Battle Creek Alliance Defiance Canyon Raptor Rescue

2/4/2020

Comment regarding THP 2-19-00180 TEH Rio Gatito

The following comments are submitted on behalf of Battle Creek Alliance (BCA) regarding Timber Harvest Plan 2-19-00180 TEH (named Rio Gatito, "Rio"), submitted by Sierra Pacific Industries (SPI). Please consider these comments as significant environmental concerns raised during the review team process, and accordingly, provide a written response to each point raised prior to issuing a Notice of Conformance for this THP.

Figure 1. Cal Fire FPGIS map of timberland in Battle Creek watershed. Industrial timberland accounts for 34% of the watershed's land area, as detailed in Table 1.

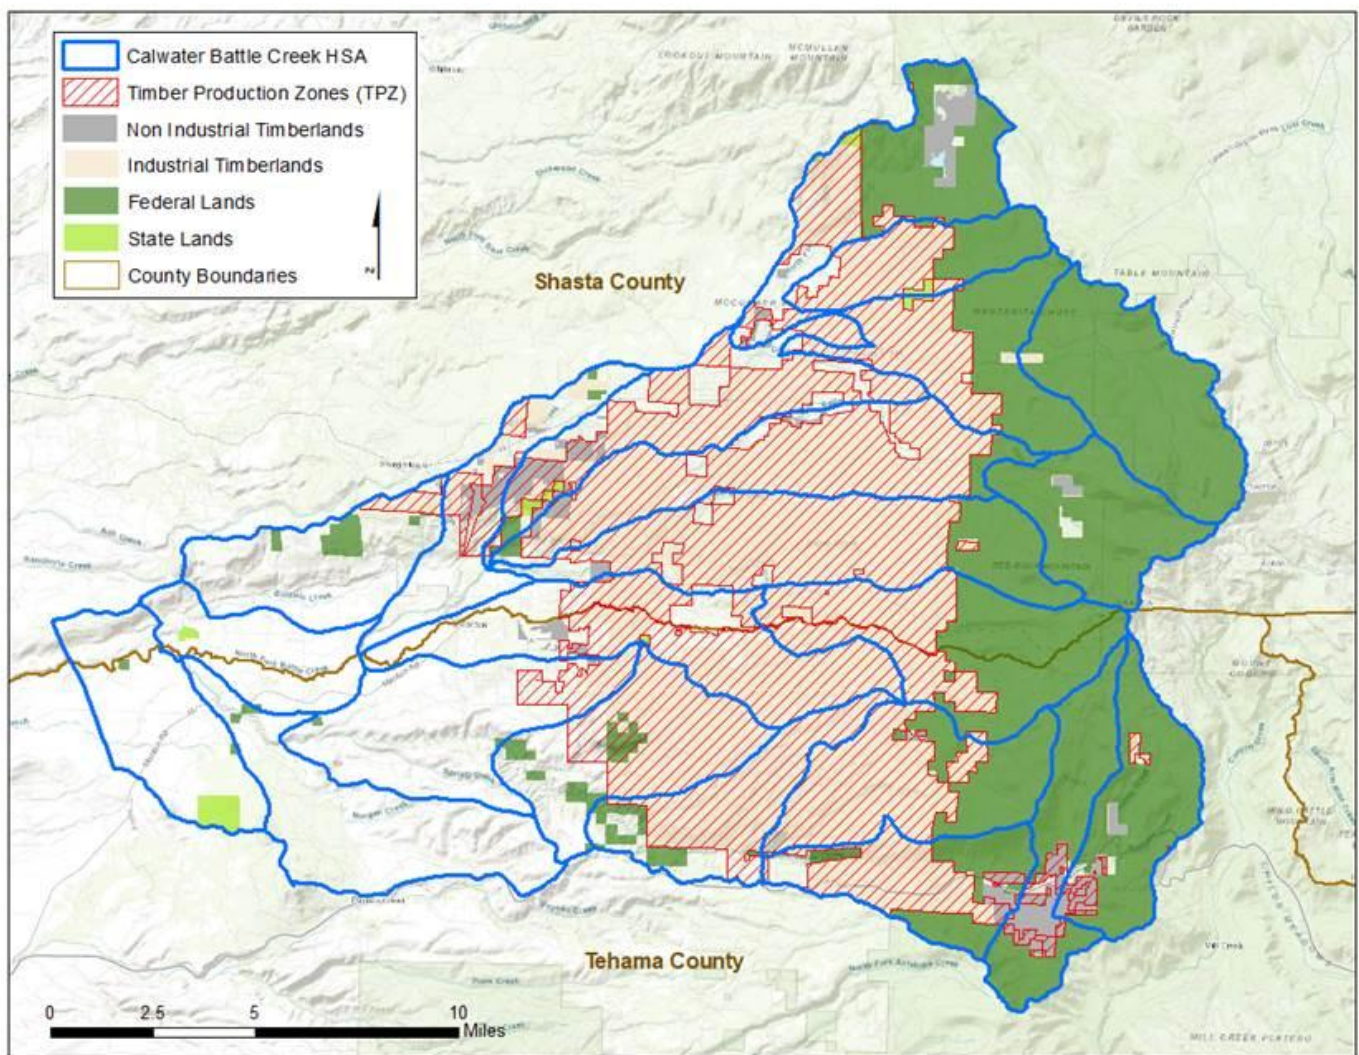
1. According to Cal Fire Forest Practice GIS data (FPGIS), over 75,000 acres of industrial timberland exists in a large, contiguous block in the Battle Creek watershed. (Figure 1, Table 1.) The cumulative impacts to this large block of land have never been analyzed in SPI's THPs under the practices CDF has followed for decades. The effects on downstream waterways have not been accounted for, or protected from significant effects, by this practice. The biota population was not assessed prior to the major landscape changes, and no ongoing study has been undertaken to assess what changes have occurred. For decades, professional hydrologists have made observations such as: "**Examination of recently approved THPs and SYPs indicates that plans are being approved that do not contain technically valid cumulative impact assessments.**" (3, see also 4,5)

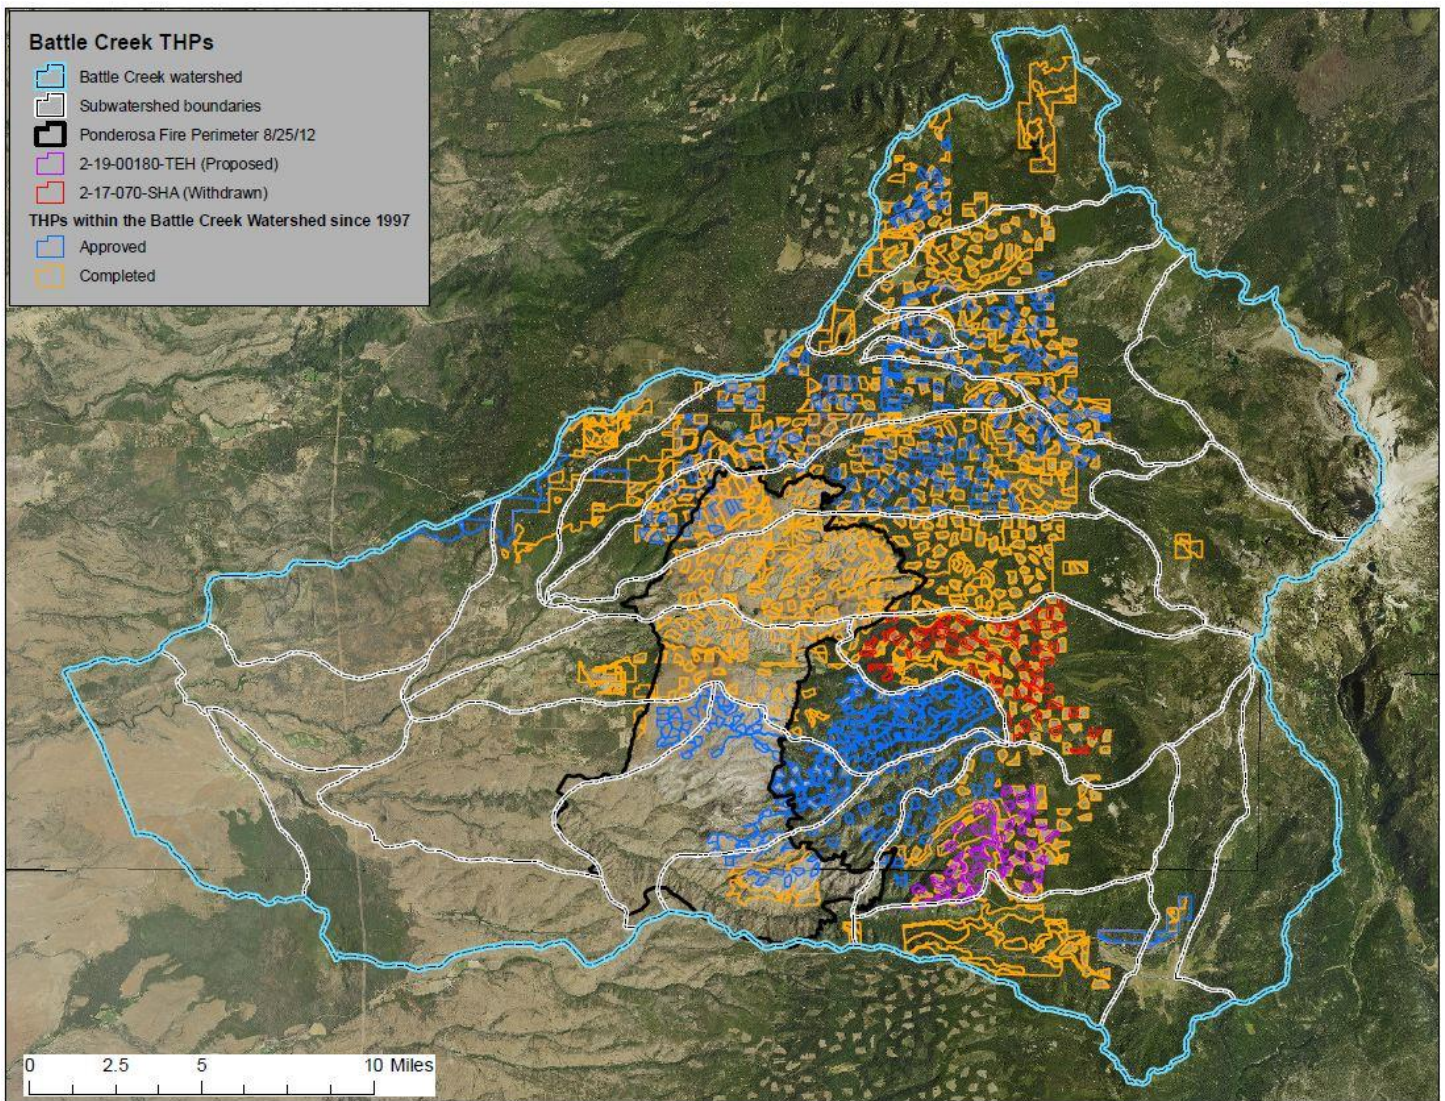
2. According to Cal Fire's records, 67 THPs covering over 61,000 acres have been filed in the eastern part of the Battle Creek watershed between 1997 and 2016. (Figure 2.) The 61,000 acres of plans does not include additional acres logged under emergency and other types of exemptions, such as the post-fire salvage logging of the 2012 Ponderosa Fire which covered over 27,000 acres. 61,000 acres is over 80% of the 75,874 acres of industrial timberland. We don't have the figures to add in the number of acres cut under exemptions, but assume that it is Cal Fire's duty to include them in order to provide an adequate cumulative impacts analysis. This is an extremely high rate of harvest, with known impacts in scientific literature. (2, 3, 4, 5,6)

Figure 2. Map of units from past THPs within the contiguous timberland block, with the proposed units of this THP marked in violet. Streamflow generally begins on the eastern (right) side of the map and flows west (left side), eventually reaching the Sacramento River. Due to SPI's pattern of minimizing the assessment area of significant cumulative impacts, many downstream impacts are being ignored.

Figure 3. A comparison between CDFW's LEMMA map of tree diameter sizes with the FRAP watershed planning map shows that most of the remaining trees of larger size diameter are only on the uncut land of Lassen Forest on the east side of the planning watershed, above SPI's land.

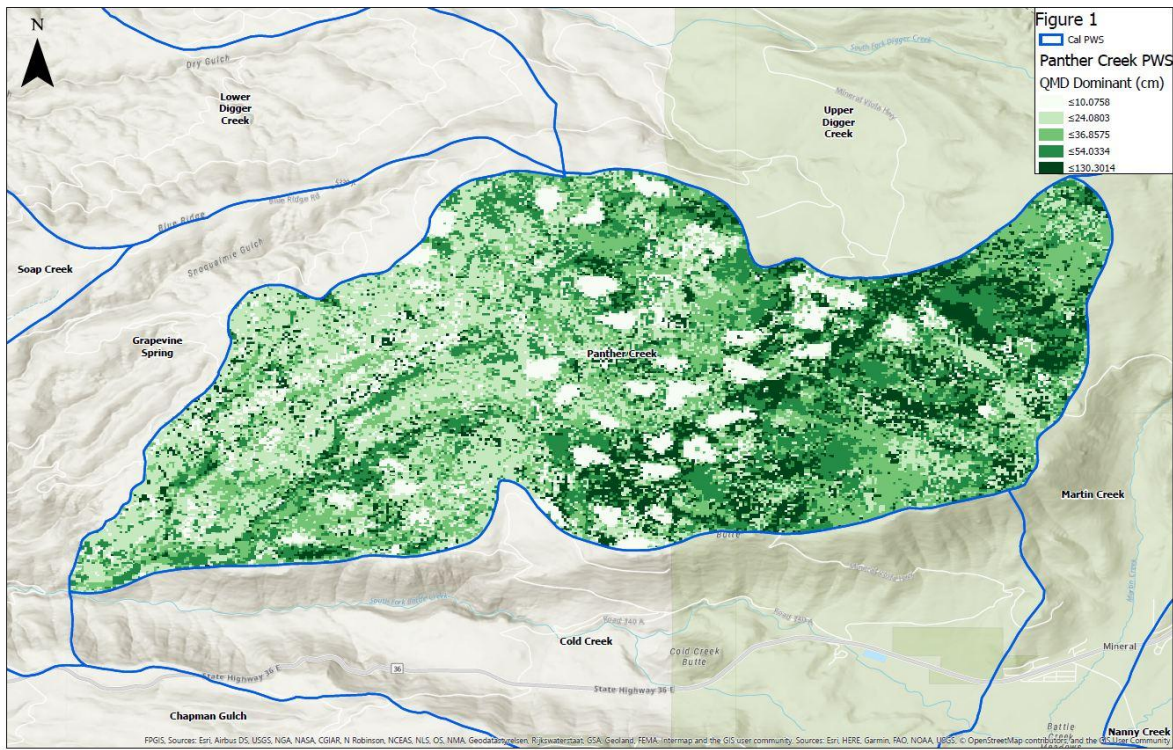
Figures 1 to 5 from LEMMA which CDFW provided in their memorandum do not have the borderlines of SPI's and Lassen Forest's land marked. The memorandum uses the 2012 data to discuss different habitat values and usually remarks that the values are higher for the public land than the industrial timberland, which can be seen in the figures if you are conversant with the approximate boundaries between the two. Unfortunately though, CDFW groups the two differing lands together when providing mean and median values, which disguises the lower values occurring on SPI land. The Lassen Forest land is primarily upstream and at a higher elevation than SPI land, which means that even though it offers some better habitat value and raises the mean and median values, it does not mitigate the downstream impacts and loss of habitat from SPI's land.

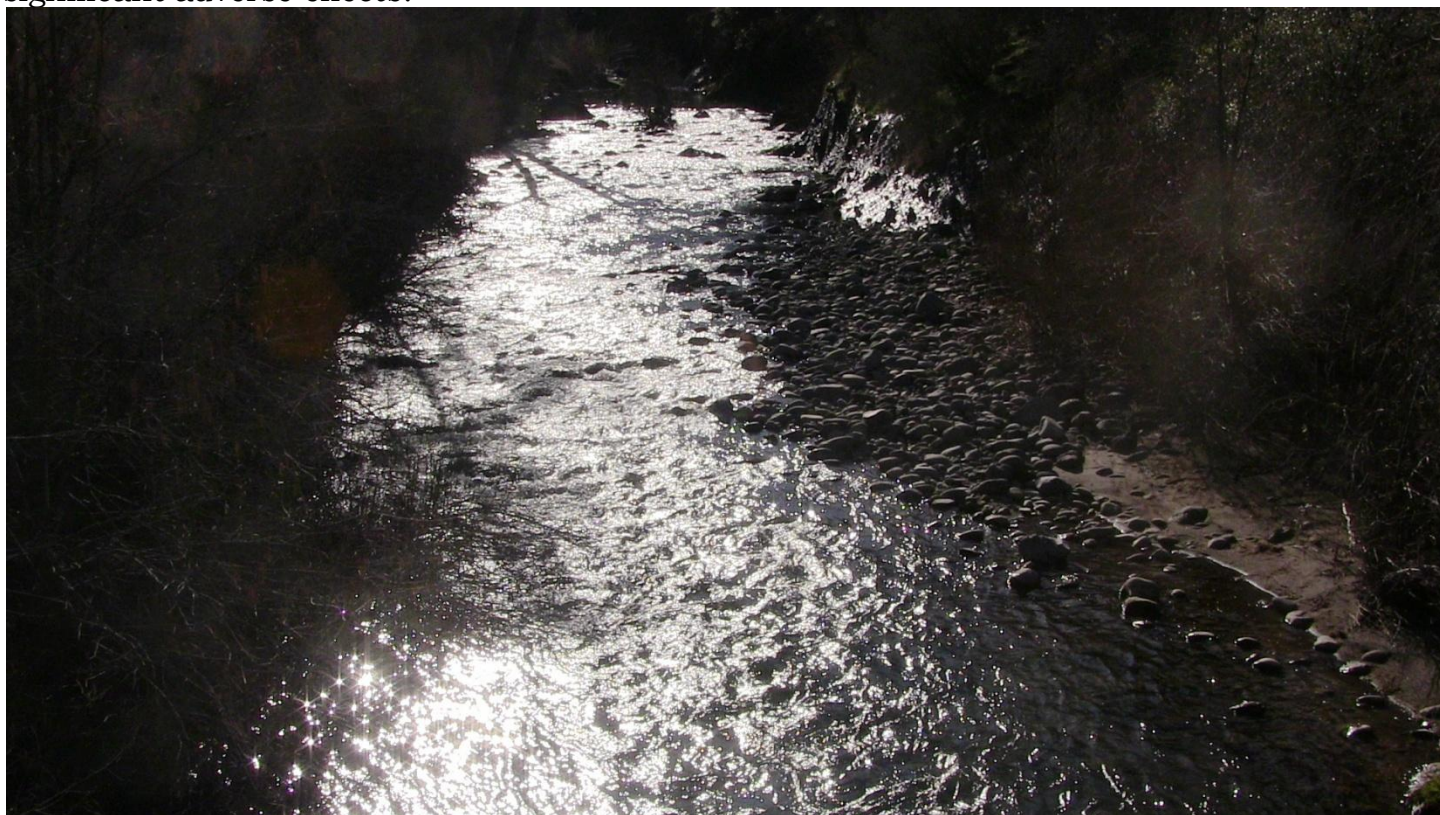
found evidence of this for over 10 years now. "The data reveal strong associations of turbidity with the proportion of area harvested in watersheds draining to the measurement sites." (2) There is more discussion of our evidence, and other entities' evidence, in our citations. Some documents mention the data gaps which exist. This is a problem, but does not mean that this plan should be approved which has no evidence in it to prove anything it asserts. We are a small, little-funded organization and cannot perform the large studies that cost hundreds of thousands of dollars that many reports have recommended. But those large studies have never been carried out, while we have accomplished collecting the data we are able to for over 10 years. Our south fork of Battle Creek site, which is downstream of the Rio plan's planning watershed, shows elevated turbidity, temperature, and pH and exceedances of the numerical limits of the Water Board's Basin Plan. Along with sampling data, we photograph each of our water monitoring sites. Figures 4 to 7 are a few visual comparisons of tributary creeks in Battle Creek watershed. All of our lower downstream monitoring sites have the same physical changes demonstrated in Figures 5, 6, and 7.

Figure 7. Our south fork Battle Creek site in 2020, downstream of Panther Creek. Sediment deposition may be seen on the bank in the lower right hand side of the photo. Significant channel modification has also occurred right above the sediment in the form of many more (and larger) boulders than in the past.

Figure 11. 2008, the first year there is data available at the south fork Battle Creek station.

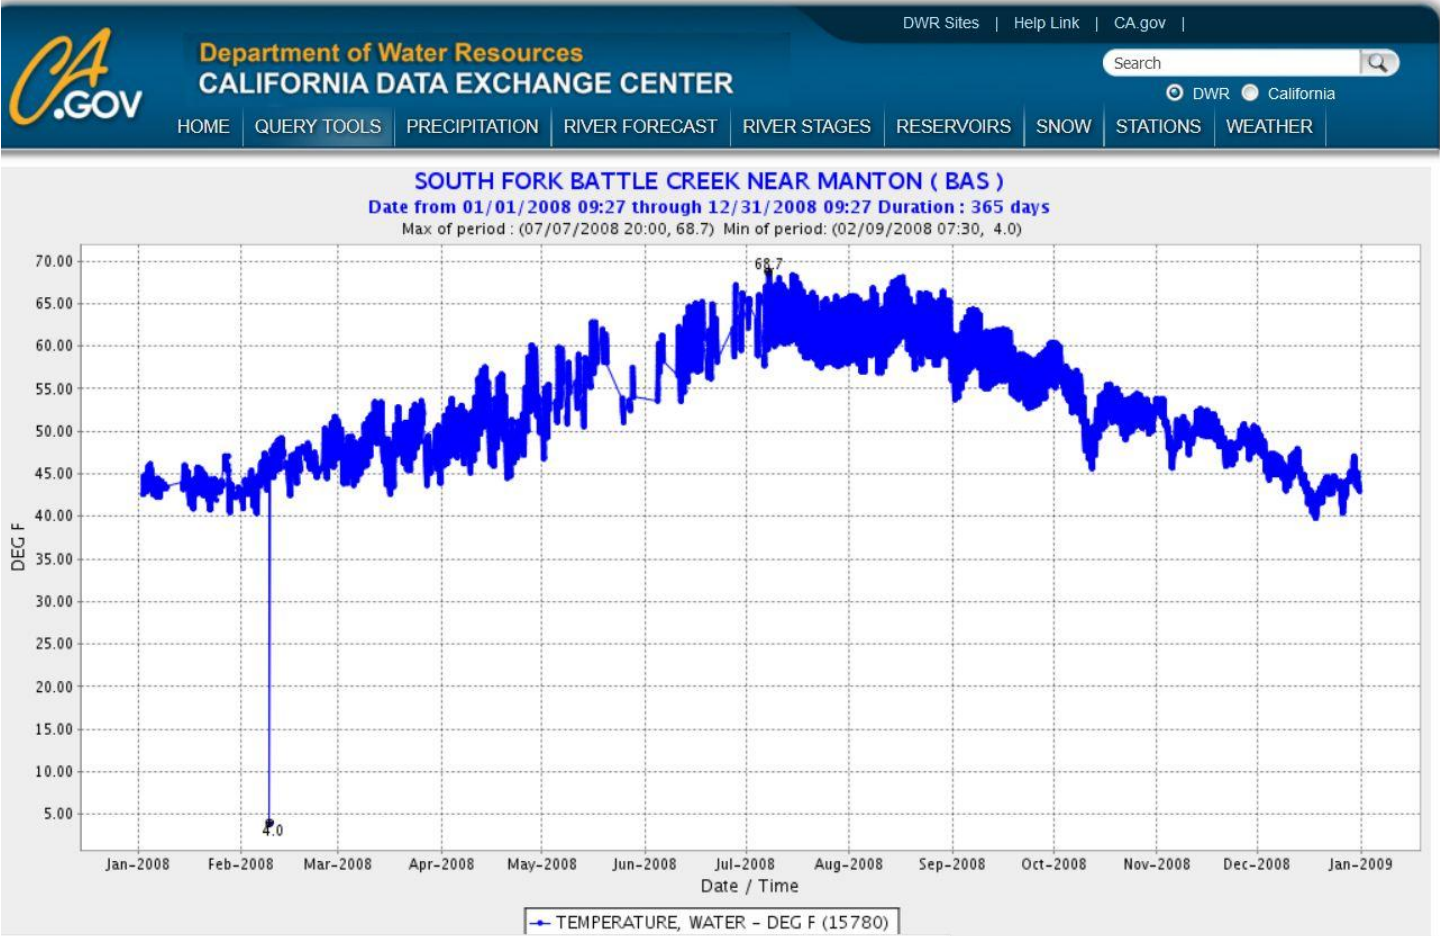
This survey did not mention any data regarding the ongoing high stream temperatures. Hydrologist Jack Lewis wrote of temperature issues in his expert opinion letter in 2018, which was submitted as a comment on a nearby plan (28). (E.g. "The BCA data sets show very clearly that the combination of wildfire and salvage logging have had major impacts and that the water quality downstream from the project area (measured at [site] DCH) is severely impaired, especially with regard to water temperatures and salmonid tolerances".) Figures 11 and 12 are graphs of Department of Water Resources stream temperature data from the south fork of Battle Creek, in the vicinity of where the highest upstream point of the referenced USFWS survey was performed. It is also at the same site that our SFB water quality samples are taken, downstream of the Panther Creek planning watershed (1). Figure 11 illustrates stream temperatures in the south fork of Battle Creek in July, 2008. Figure 12 is the data from 2019, provided for comparison. As may be seen in the graphs, the temperature was elevated above 65° for a much longer period in 2019 than in 2008. Many aquatic species need temperatures below 68° (20°C) to survive; lower temperatures than that are optimal (29).

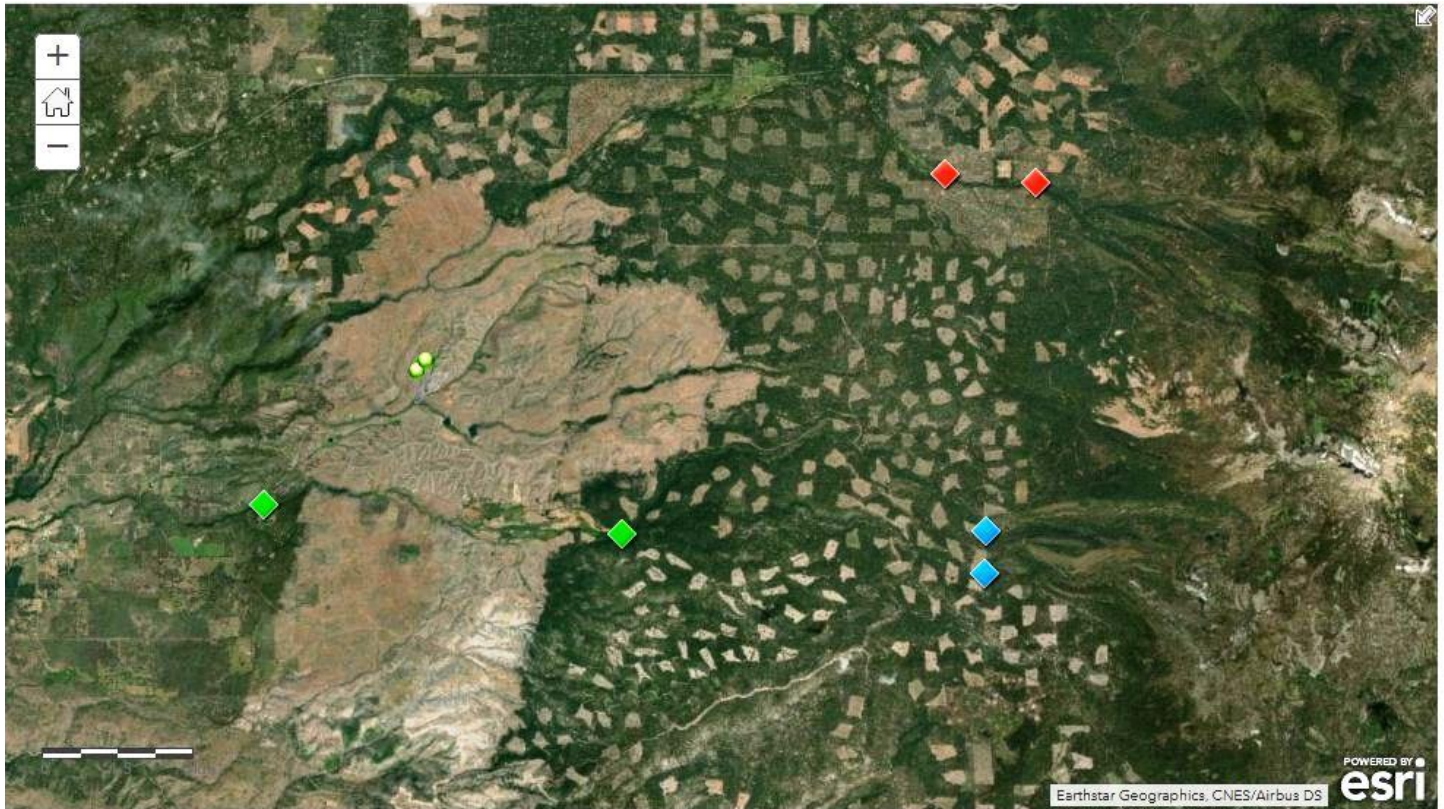
Under "Records Examined" in Section 4 of this THP, the SPI-produced "Bioassessment and Water Quality for South and North Forks Digger Creek" document is listed. Digger Creek is to the north of Panther Creek and outside SPI's chosen assessment area for this plan. According to Cal Fire's ongoing practices and statements, that is unacceptable when we do it.

Figure 13. The industrial timberland area of Battle Creek watershed. The regularly spaced brown holes are clearcuts. The large brown area is from the Ponderosa Fire of 2012 and the subsequent salvage logging of it. The uncut area on the right hand side is Lassen National Forest where the Battle Creek tributaries, Digger, Bailey, and Panther Creeks, originate. The green diamond shapes mark 2 of our water monitoring sites on Digger Creek, the right hand being the higher (upstream) site. The blue diamonds mark the Digger and South Fork Digger Creek locations at the boundary between SPI and Lassen Forest land. The red diamonds mark SPI’s data stations on Bailey Creek as detailed in the SPI James and MacDonald 2012 report regarding Bailey Creek.
